GULF STATES UTILITIES COMPANY

December 9, 1983

River Bend Station Units 1 and 2
Docket Nos. 50-458/50-459

Enclosed are Gulf States Utilities Company's responses to Request for Additional Information identified by the Nuclear Regulatory Commission's Instrumentation and Control Systems Branch (ICSB) and endorsement of the Licensing Review Group-II issues 1-ICSB through 7-ICSB. Attachment 1 of this letter summarizes the Staff requests identified in a letter dated July 28, 1982. The following enclosures contain the actual written changes to the FSAR including all inserts, tables, and figures. These changes will be incorporated into the FSAR in the next amendment.

To be new Fig. 7.2-1 (4 Sheets)

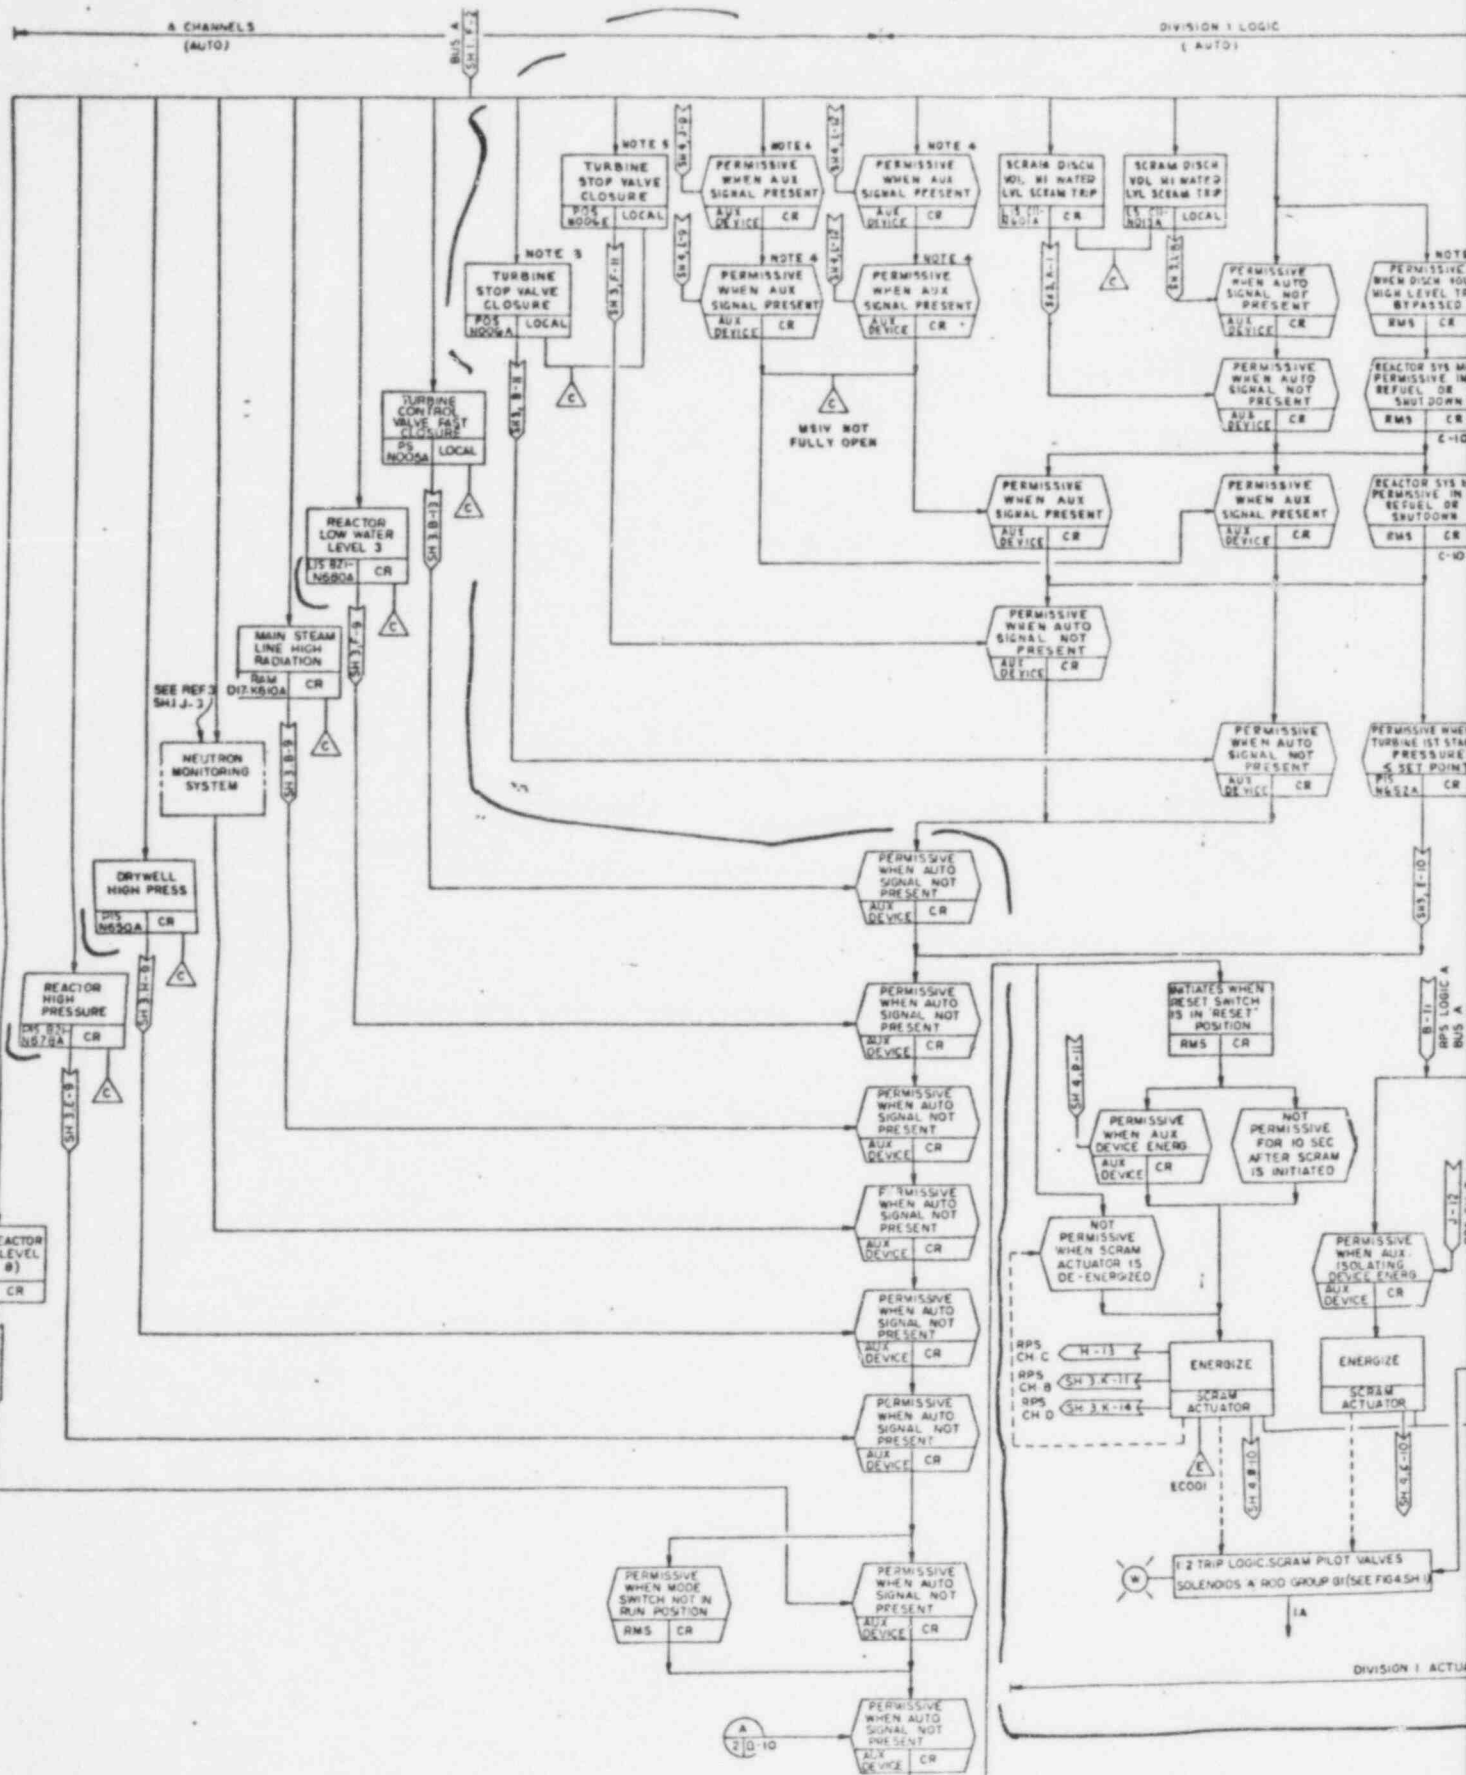
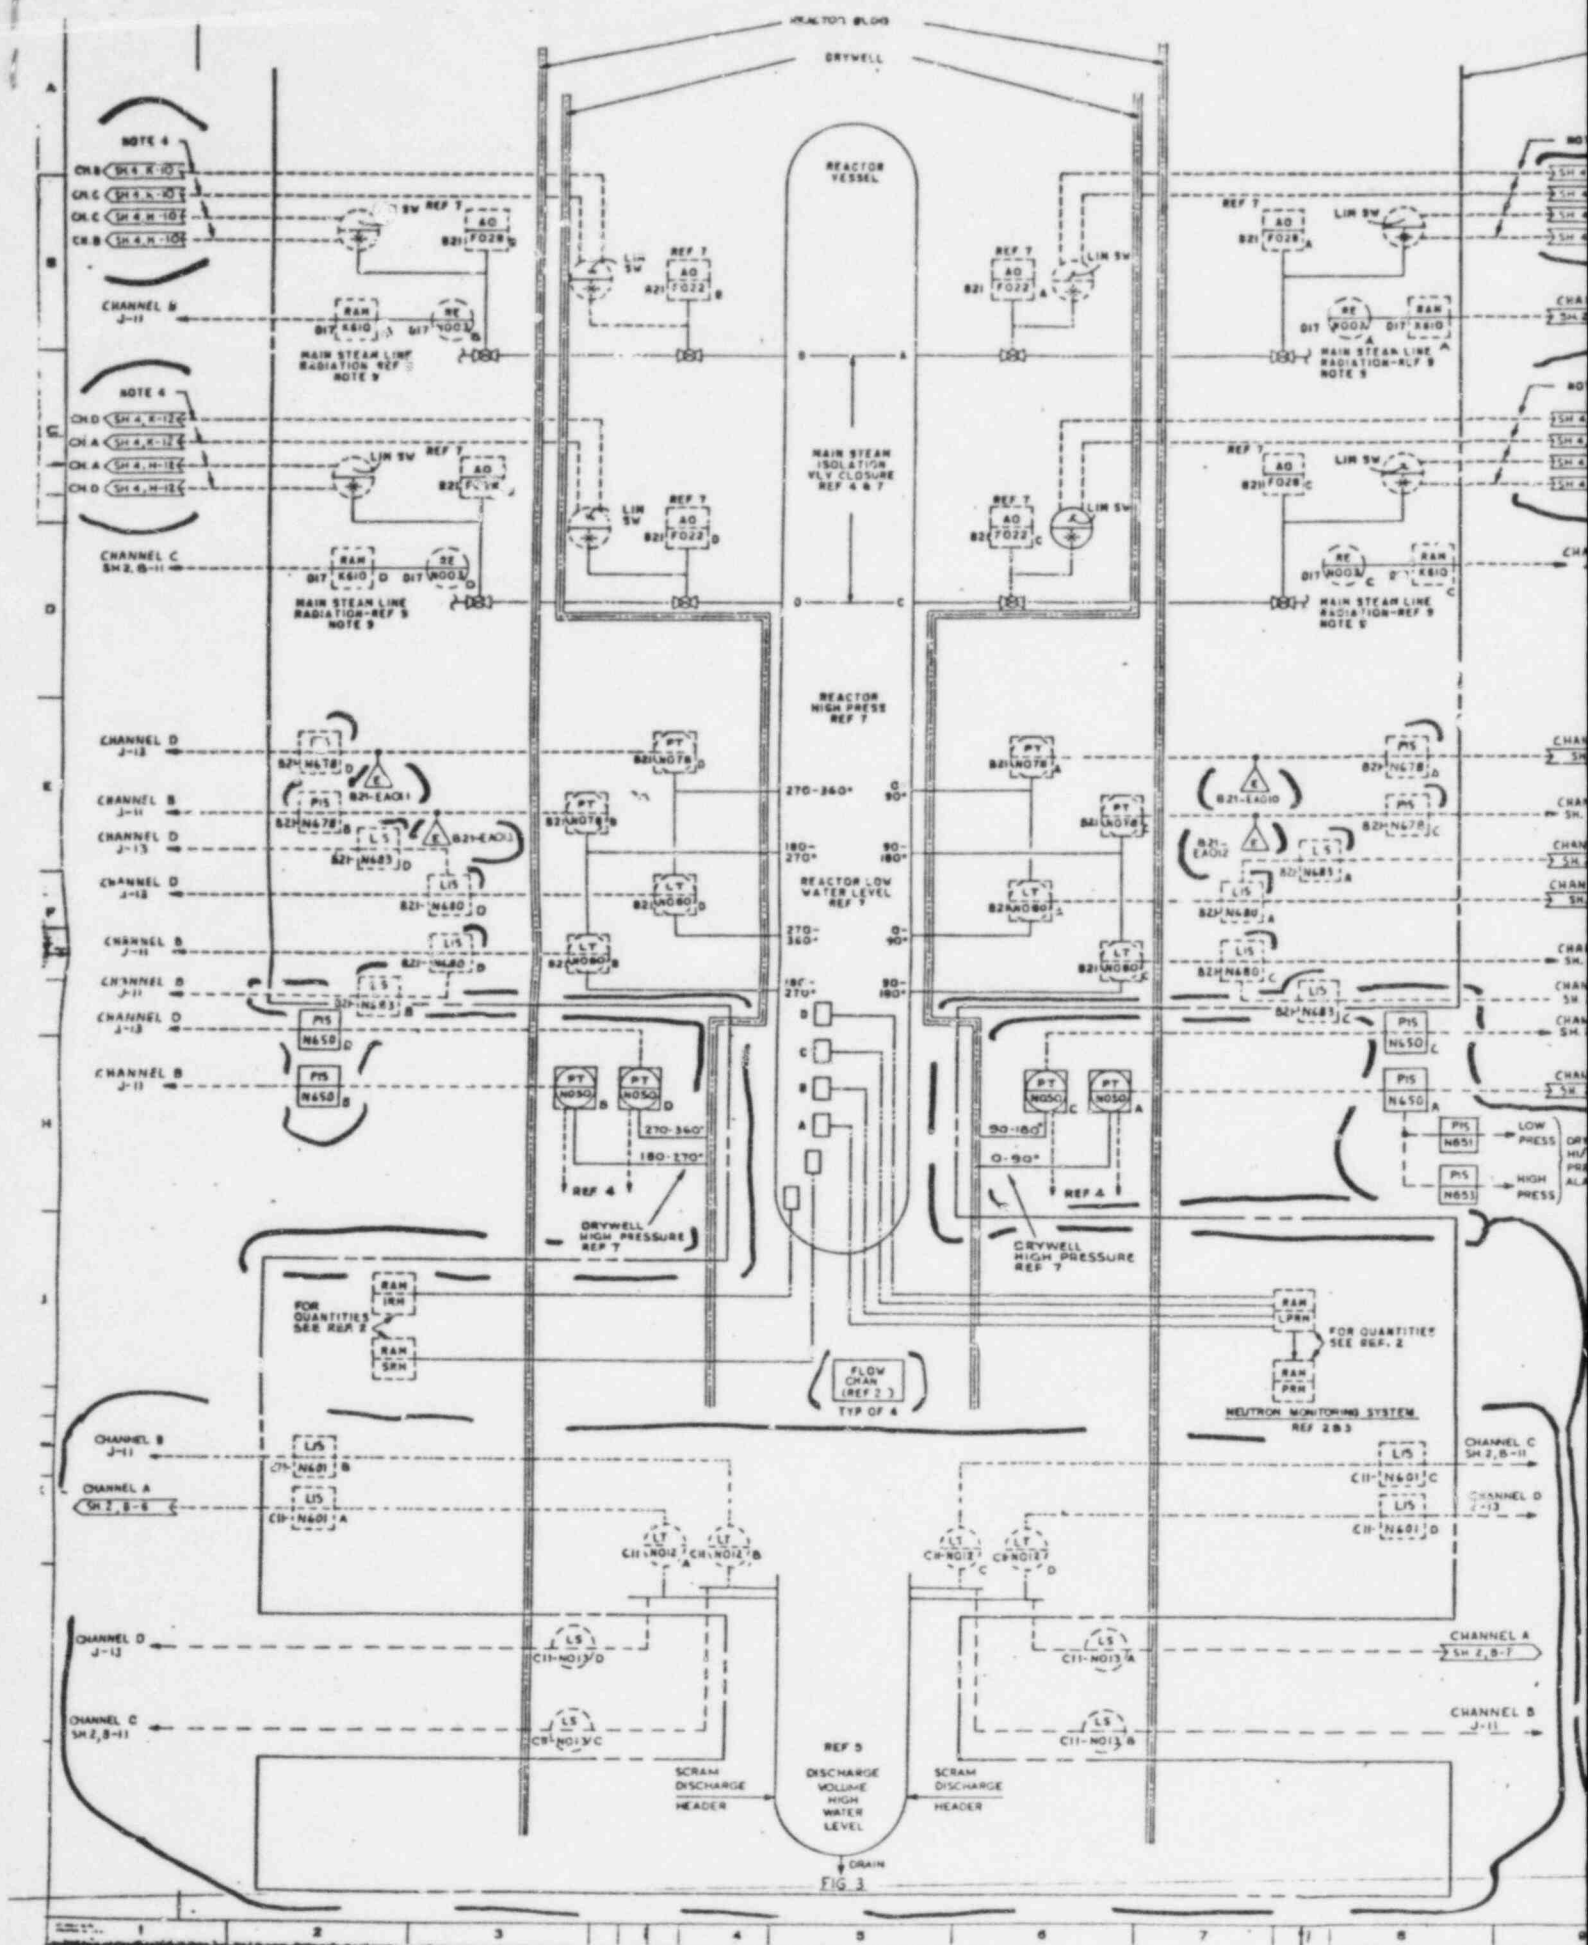
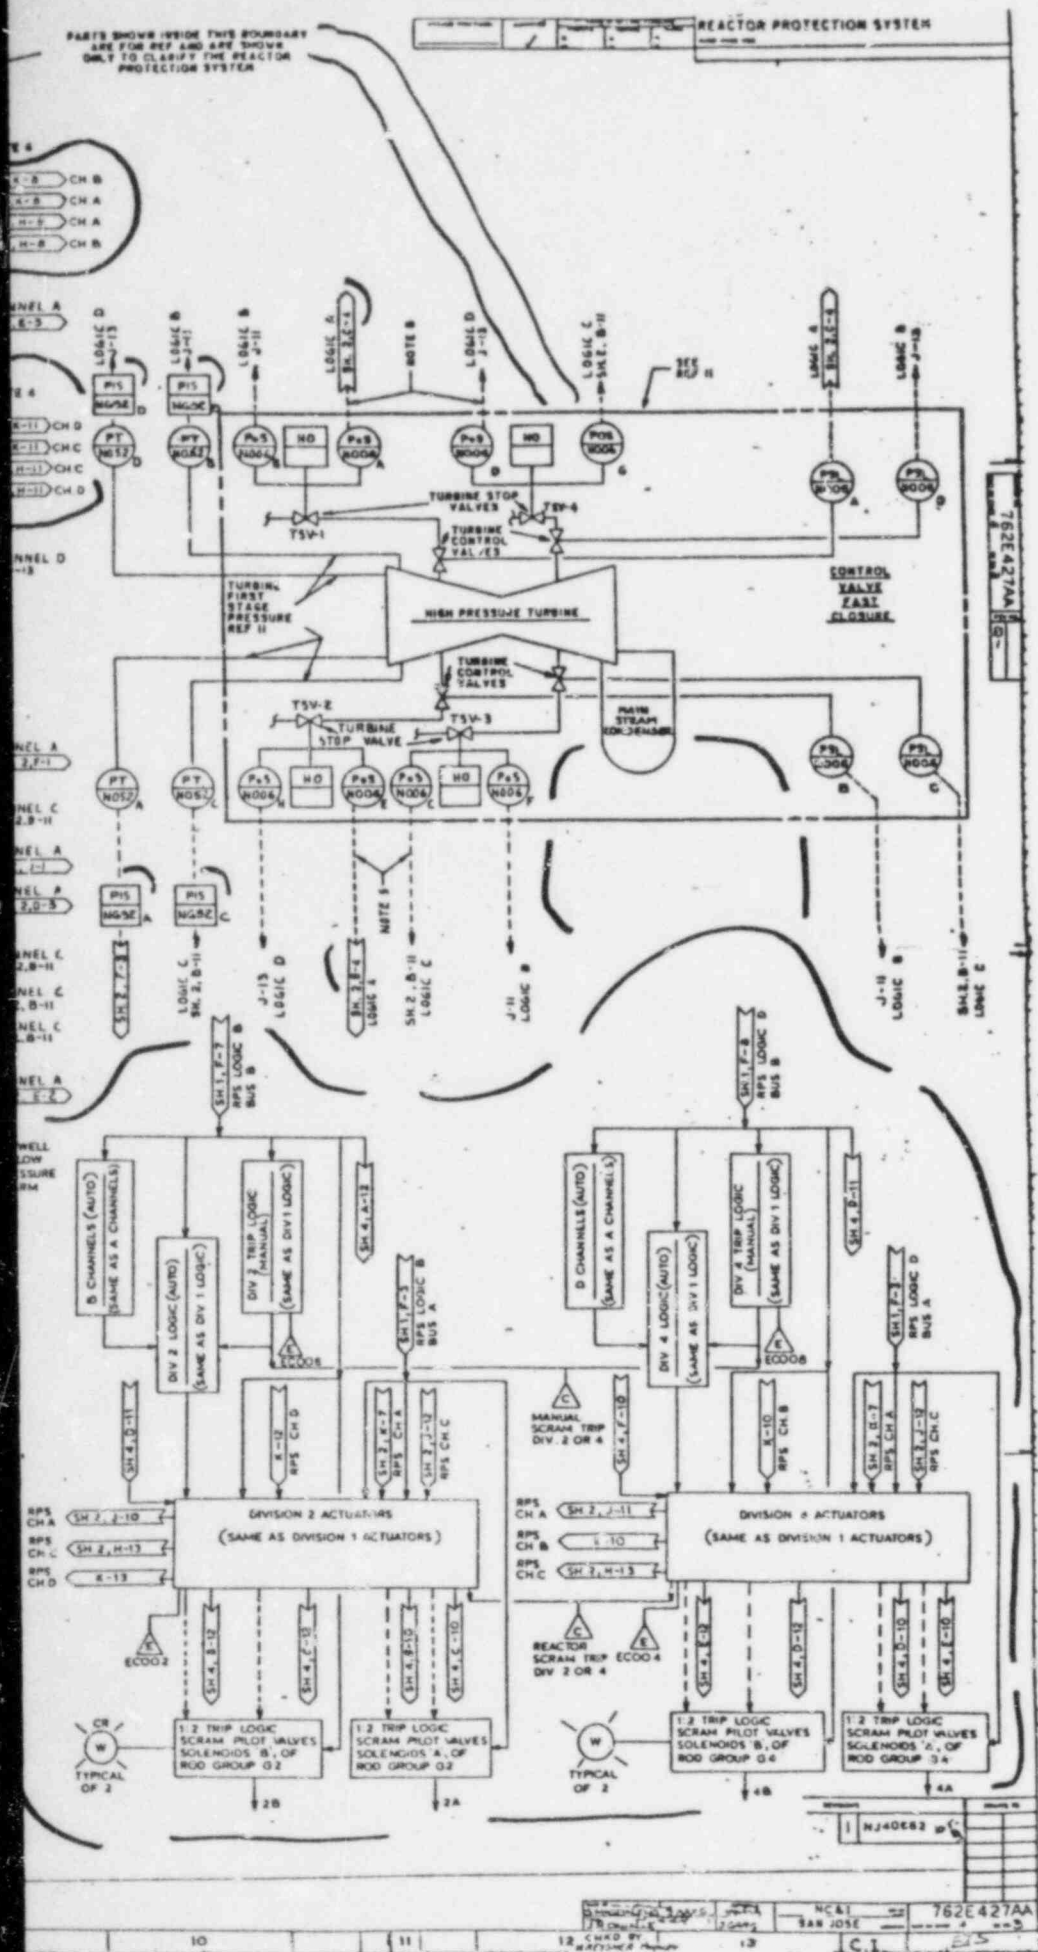
During an earlier review (Hatch Unit 2), the staff questioned the adequacy of protection afforded the Class 1E RPS against possible sustained overvoltage or undervoltage conditions from the non-Class 1E RPS power supply. Several similar plants (i.e., Perry and Grand Gulf) have provided an electrical protection assembly (EPA) between the RPS and its power sources. No reference to the EPA could be found in Chapter 7 or 8 of the River Bend FSAR. State whether the River Bend design will incorporate an EPA between the RPS and its power sources. If so, the FSAR should be modified accordingly. If not, describe how the RPS is protected from degraded voltage and frequency conditions.

The discussion on Scram Discharge Instrument Volume (SDIV) Water Level, FSAR Section 7.2.1.1, states that four pressure (level) transmitters sense SDIV level and provide inputs to the RPS. However, Section 4.6.1.1.2.4.2.5 states that both float sensing and pressure (level) sensing devices are used for the automatic scram function. Resolve this apparent discrepancy.

④ 421.016 ⑤ 421.021
